Docket No. 50-423

Reference: B. J. Youngblood letter to W. G. Council, Request for Additional
Information, dated June 19, 1984.

Millstone Nuclear Power Station, Unit No. 3
Probabilistic Safety Study (PSS)

FIGURE 720.86-1a. TYPICAL CROSS-SECTION THROUGH CONTROL BUILDING FOUNDATION

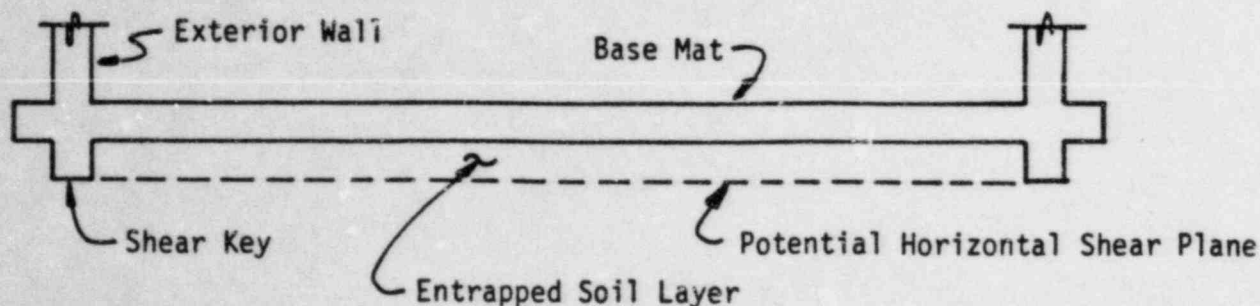
Your sliding analyses of the control building and the emergency generator enclosure may be nonconservative. We believe you assumed the shear resistance equals the arithmetic sum of the soil friction resistance and the flexural strength of the shear keys. Provide a basis for such an assumption or reanalyze using a failure plane developed along the bases of the shear keys which cut through the soil.

The control building is supported on a single base mat typically 4'-0" thick. The base mat bears on one to four feet of compacted structural backfill overlying basalt fill varying from one to fifteen feet in thickness. Shear keys into the soil were provided beneath the exterior walls. A typical cross-section through the control building foundation is shown in Figure 720.86-1a.

FIGURE 720.87-1. MEDIAN SITE-SPECIFIC GROUND RESPONSE SPECTRUM

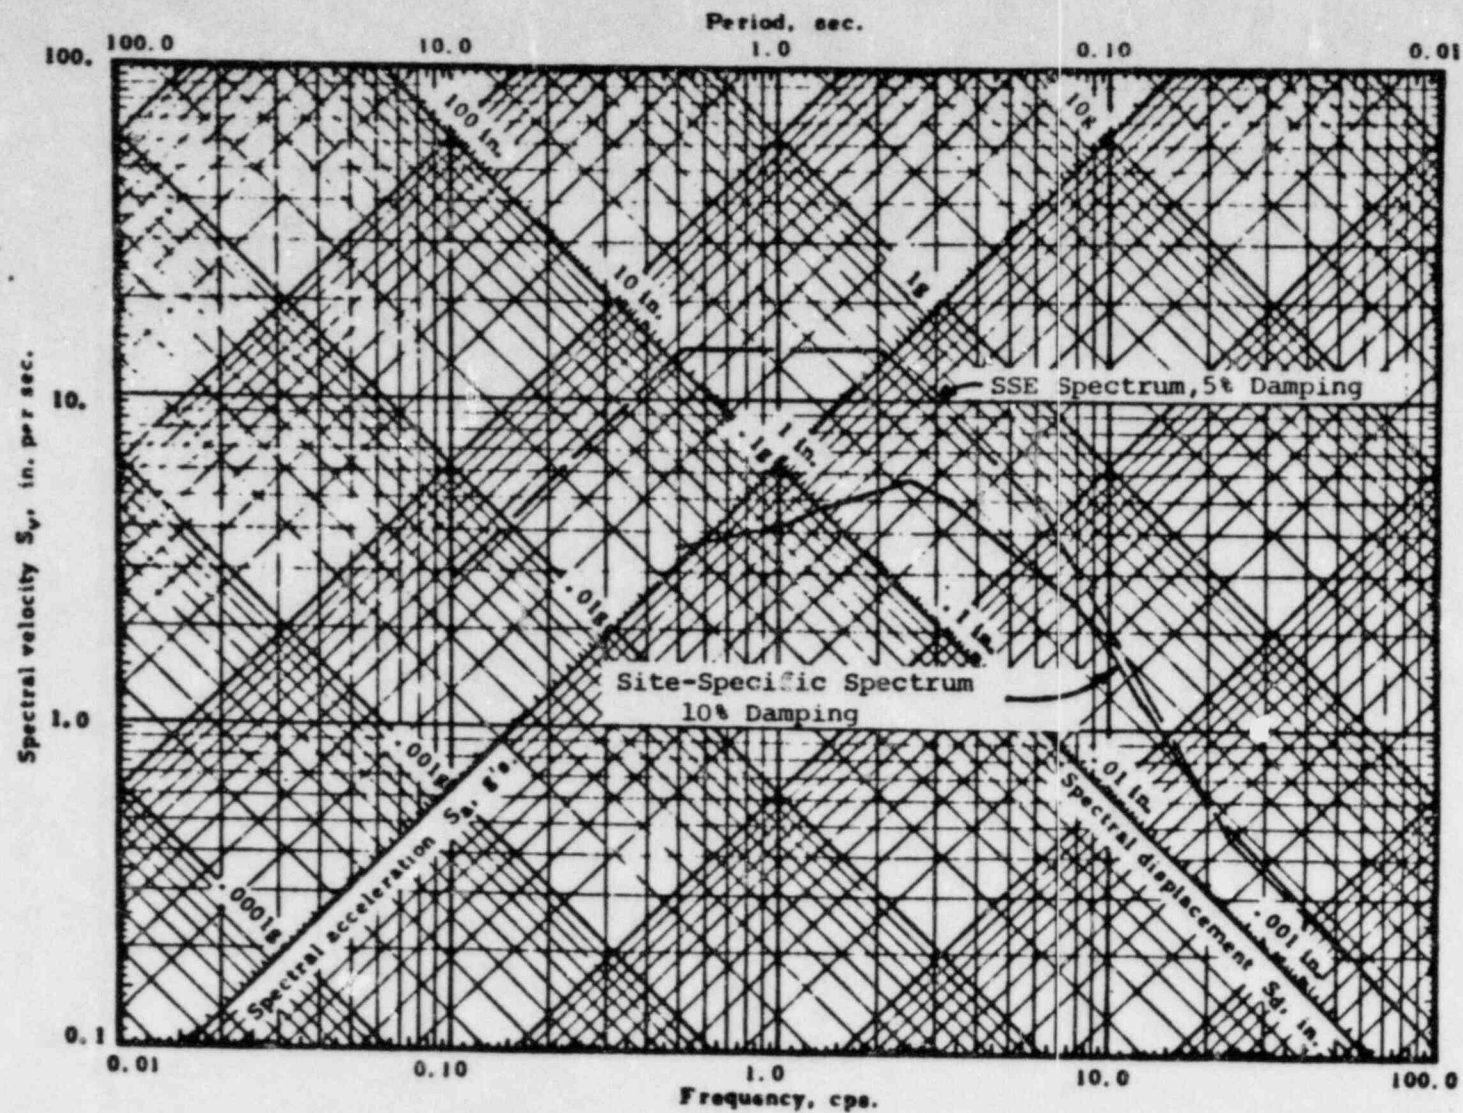
We believe your analysis of the emergency generator enclosure assumed the foundation was anchored in till. We understand the enclosure actually has a foundation partly on till, partly on fill, and partly on till and fill. We believe a new analysis, taking into account as-built conditions, may show your analysis is optimistic. Demonstrate your analysis is not overly optimistic.

If the original design seismic analysis assumed that the emergency generator enclosure was founded on basal till rather than a combination of backfill and till, reductions in the frequencies from these values originally calculated would be implied. The structure failure modes having the lowest median acceleration capacities result from north-south seismic response. Inspection of the in-structure response spectra shown in FSAR Figures 3.7 B-52, 55, and 58 indicate that modes having frequencies of about 9 Hz and 14 Hz contribute the most to response in this direction. Spectral accelerations at these frequencies for the median-centered, site-specific ground response spectrum can be obtained from Figure 720.87-1 (taken from Figure 3-1 of Reference 1). The spectral accelerations are nearly uniform at the maximum value around the fundamental frequency of approximately 9 Hz. In fact, a reduction in response would be expected if a revised representation of the soil stiffness resulted in a fundamental frequency less than about 8 Hz since spectral accelerations begin to decrease at this value. A slight increase in the seismic response associated with the second mode would be expected. However, significant change in the second mode response would require a substantial reduction in the soil stiffness.
